Intersection ID: 8483	Main Street: KENNESAW_DR	Cross Street: LASALLE_ST	Location:	SW
ADA ID: 2E544427841B	Ramp Type: PerpDiag	Initial Pass/Fail: Fail	Overall Compliance: No	Severity Score: 46.25

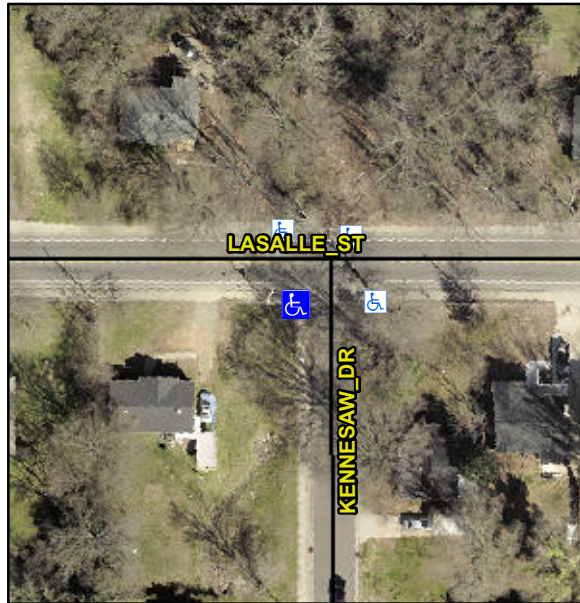
**Not Found, R304.5.1, R304.2.2,
R304.5.3**

Remove & Replace Curb Ramp With Two New Directional Ramps or Equivalent.
